UNITED STATES PATENT AND TRADEMARK OFFICE

APPLICATION NO.	FILING DATE	FIRST NAMED INVENTOR	ATTORNEY DOCKET NO.	CONFIRMATION NO.
10/646,863	08/25/2003	Tae Hwan Jung	1594.1274	1800

Office Action Summary

This is a first office action on the merits of application SN 10/646,863.

Cherry '747 Figure 7

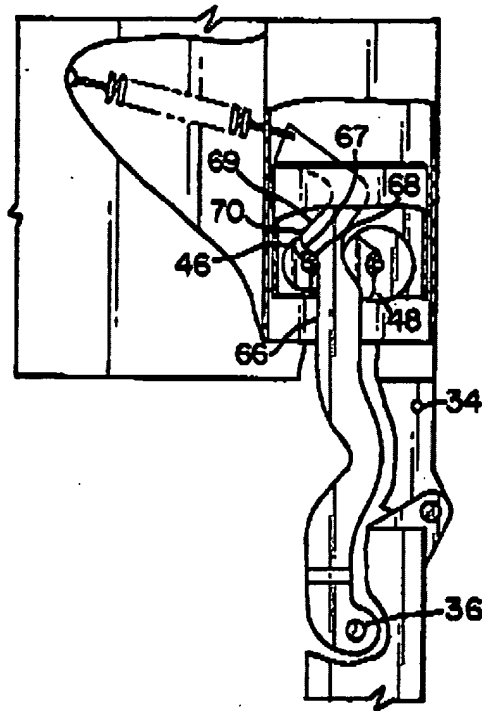
7. Claims 1, 2, 6, 7, 12, 14, 28, 29, 34, 35, and 40 are rejected under 35 U.S.C. 102(b) as being clearly anticipated by U.S. Patent 5,220,747 to Cherry. Cherry '747 discloses a door control device for a refrigerator (10) having a refrigerator door (14). A movable body (38) is coupled to the refrigerator door (14). Wherein the movable body (38) is arranged to move in opposite directions in accordance with opening and closing actions of the refrigerator door. A control unit (54, 54a) controlling an opposite directional movement of the movable body in a multi-stage manner.

Cherry '747 Figure 4

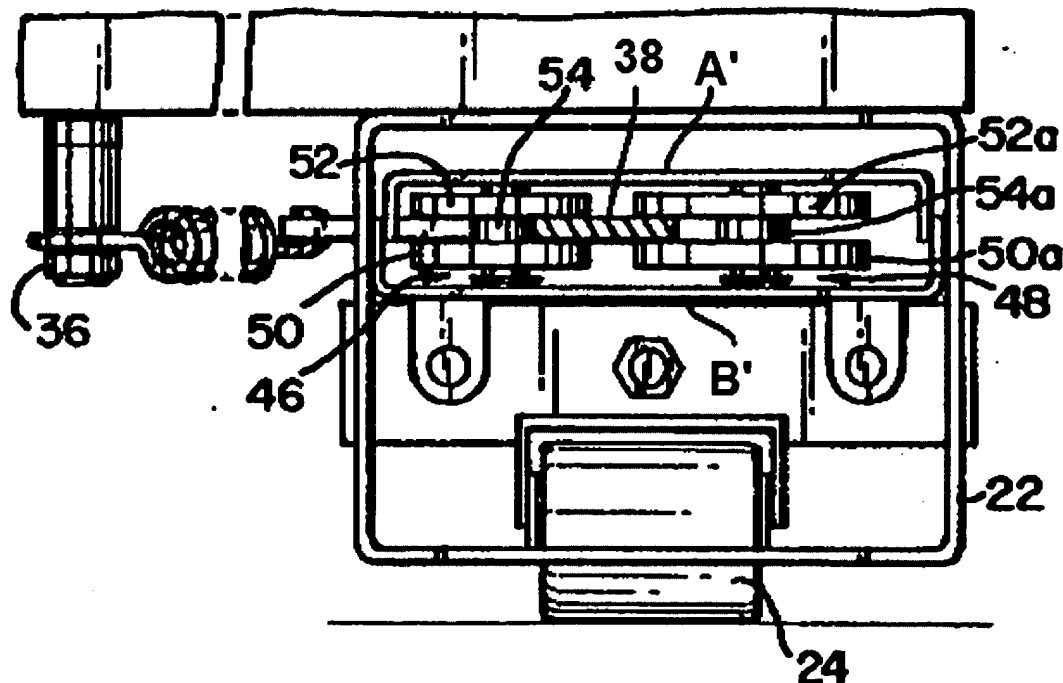
8. Regarding claims 14 and 28, the refrigerator (10) is defined as a cabinet (11) with a storage compartment (12). The door (14) is hinged to the cabinet (11) to close the storage compartment (12). The device is disposed in a leg casing (22) at a lower portion of the refrigerator (10) as best shown in figure 1.

9. Regarding claims 2 and 29, a guide element (50,52,50a, 52a, A', B') contains the movable body (38) and guides the opposite directional movement of the movable body.

10. Regarding claims 6 and 34, the movable body (38) is provided with a plurality of grooves (65,68) formed along a longitudinal side surface.

11. Regarding claims 7 and 35, the control unit (54,54a) comprises a locking unit (54, 54a) selectively engaging with the plurality of grooves provided to the movable body.

12. Regarding claims 12 and 40, the grooves (65,68) of the movable body (38) are smoothly curved to form a waved configuration.

Sparkman '778 Figure 2

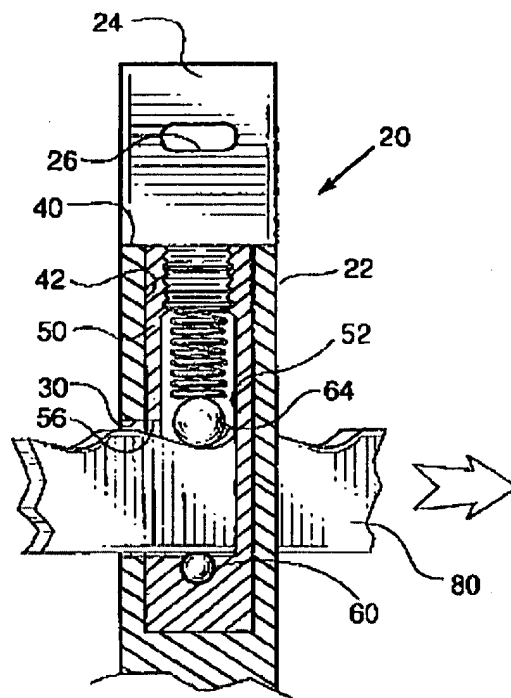
15. Claims 8-11, 15-17, 36-39, and 42-44 are rejected under 35 U.S.C. 103(a) as being unpatentable over U.S. Patent 5,220,747 to Cherry in view of U.S. Patent 6,711,778 to Sparkman. Cherry '747 discloses every element as described above. Cherry '747 does not disclose expressly the details of the locking unit, and the control unit in a control chamber and the location of the chamber. Sparkman '778 discloses a locking unit (64) selectively engaging with the plurality of grooves (88,90,92) provided to the moveable body (80). An elastic member (66) elastically supports the locking unit (64). The locking unit (64) comprises a retractable roller (64) selectively seated in the grooves (88,90,92) of the movable body (80) during a movement of the movable body (80). The roller (64) is perpendicular placed relative to the movably body (80), and wherein the roller (64) is elastically retractable. The control unit (64,66) is disposed in a control chamber (50), which is defined in a separate member (22) at a predetermined position on the sidewall (2) and is integrally fastened to the sidewall (2) with screw (28). At the time of the invention it would have been obvious for a person of ordinary skill in the art to take the device of Cherry and add the locking unit and control chamber of Sparkman to provide a plurality of stop positions.

16. Regarding claims 10 and 38, it would have been obvious matter of design choice to modify Sparkman's locking unit by having a roller bracket between the elastic member and the roller, since the applicant has not disclosed that having a roller bracket solves any stated problem or is for any particular purpose and it appears that the locking unit would perform equally well without a roller bracket.

17. Regarding claims 15 and 42, It is obvious that the control chamber is perpendicularly defined at a sidewall of the leg casing since the roller is perpendicular to the movable bar in Cherry, the control chamber is perpendicular to the roller in Sparkman, and the casing is perpendicular to the movable bar in Cherry then therefore

Jeynes '551 Figure 1

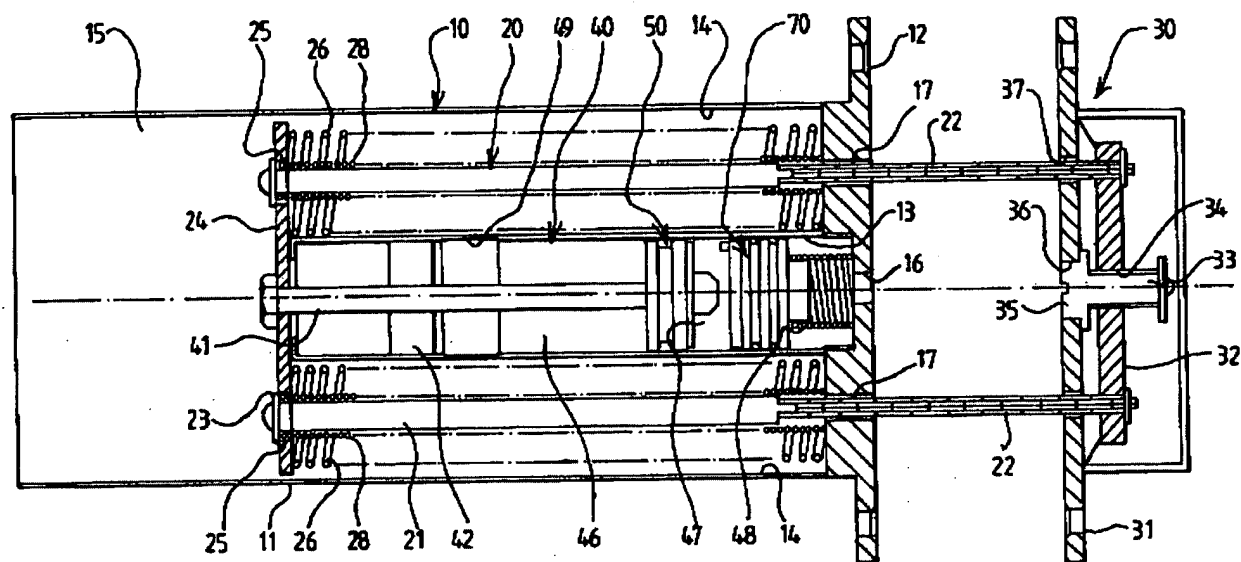
19. Claims 18-27 and 45-53 are rejected under 35 U.S.C. 103(a) as being unpatentable over U.S. Patent 5,220,747 to Cherry in view of U.S. Patent 5,706,551 to Jeynes. Cherry '747 discloses every element as described above and tension spring (56) attached to the rear of the moveable body (38). Cherry '747 does not disclose expressly a dampening unit. Jeynes '551 discloses a dampening unit (10) to close a door. The dampening unit (10) uses an elastic support unit in the means of two parallel compression springs (26) to drive the shafts (22) into the body. The compression springs are connected to a support member (30) by shafts (22). The dampening unit (10) uses a hydraulic damper (40) to dampen the rate of rearward movement during closing action, thus retarding energy generated from the door. At the time of the invention it would have been obvious for a person of ordinary skill to take the device of

Cherry and replace the tension spring with the dampening unit of Jeynes by attaching the support member to the moveable body so that the closure rate of the door is controlled.

20. Regarding claims 25-27, 52, and 53, it would have been obvious matter of design choice to modify the location of Cherry's tension spring or the dampening unit when modified by Jeynes, by having it on the inner surface of the rear wall of the leg casing, since the applicant has not disclosed that having the dampening unit inside the leg casing solves any stated problem or is for any particular purpose and it appears that the dampening unit once modified by Jeynes would perform equally well with the unit outside of the casing.
